**PLAN COMMISSION PC #16-016**  
**Marathon Gas Station/Convenience Store**  
**1706 W. Northwest Highway**  
**SU-Auto Service Station with Convenience Mart**  
**Round 1**

Address: 1706 W. Northwest Highway  
Marathon Gas Station/Convenience Store  
Special Use Permit for Automobile Service Station with  
Convenience Mart  
P.C. 16-016 Round 1

Project: Marathon Gas Station with Convenience Store  
1706 W Northwest Highway

Case Number: PC 16-016

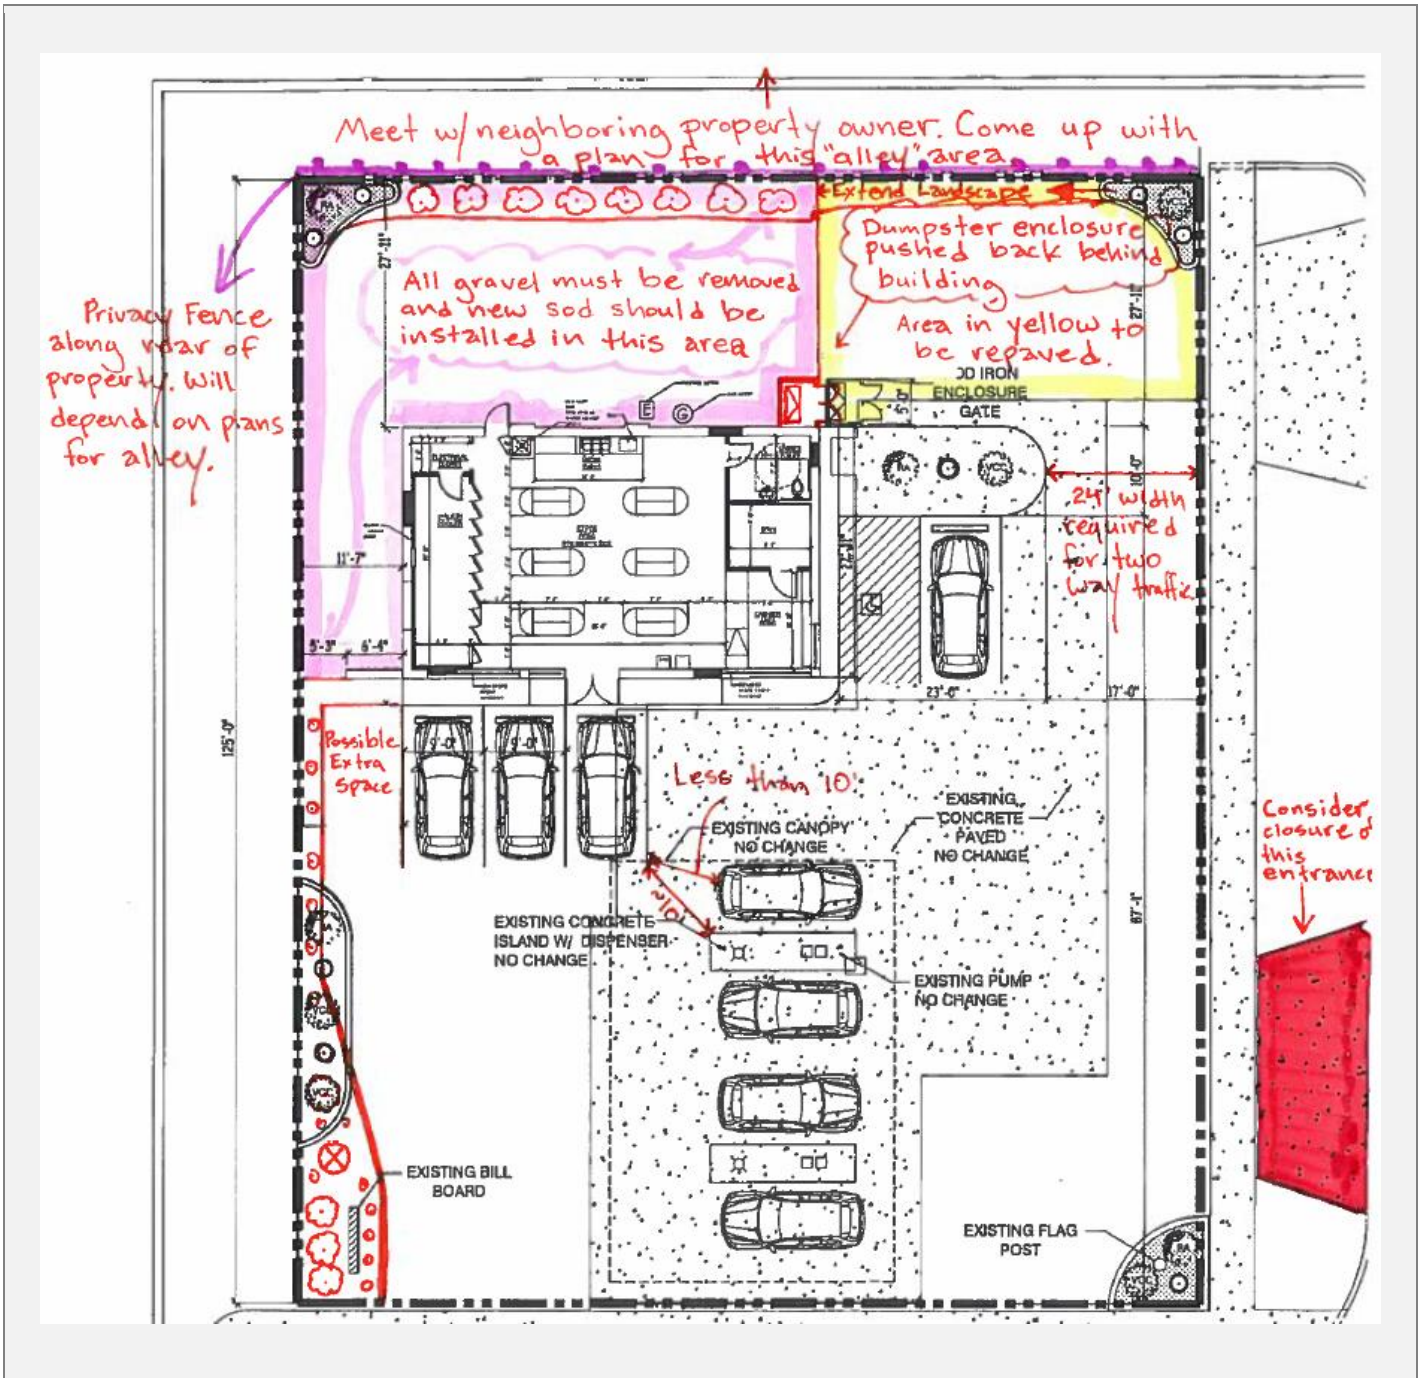
15. Dumpster enclosure should be moved back so that it is behind the rear of the building (please see the attached graphic at the end of this review.) Additionally, the materials of the enclosure should be revised so that they match the materials of the building.

16. Please alter the orientation and size of the proposed landscape island along the northwest side of the site. The location should be altered so that it provides a landscape bed for the proposed ground sign. This might also allow an additional parking spot (see attached graphic).

17. Additional landscaping, as well as a privacy fence, should be installed along the rear property line (see attached graphic). The size of this landscape area will be analyzed once the site plan has been adjusted to accommodate for the vacated alley and a plan has been determined for the vacated alley area.

18. All gravel/pavement should be removed from the area on the northwest side of the building (see attached graphic – area in pink). This area should be replaced with sod and/or landscaping.

19. The asphalt on the side of the building (see yellow area on attached graphic) should be resurfaced and must comply with all engineering standards for parking lots. A landscape island along the rear of this area may be required once a final plan for the vacated alley area is determined. Picture below documents current deteriorated condition of pavement.

20. Please analyze all parking spaces and drive aisles with respect to Section 11.2-8 and 11.2-9. It appears that there is only approx. 10' of clearance between the 3<sup>rd</sup> parking space in front of the building and the pump island (see graphic). Furthermore, it appears there would be less than 10' of clearance if a car was parked at the pump. Additionally, the drive aisle to the rear driveway entrance along Race Avenue does not appear to provide enough room for two way traffic.
21. Please evaluate the possibility of removing the entrance drive along Race Avenue, adjacent to the intersection of

Race and Arlington Heights Rd. This may allow additional parking and/or landscaping to be installed in this area (see attached graphic). This would also allow for the addition of parkway trees.
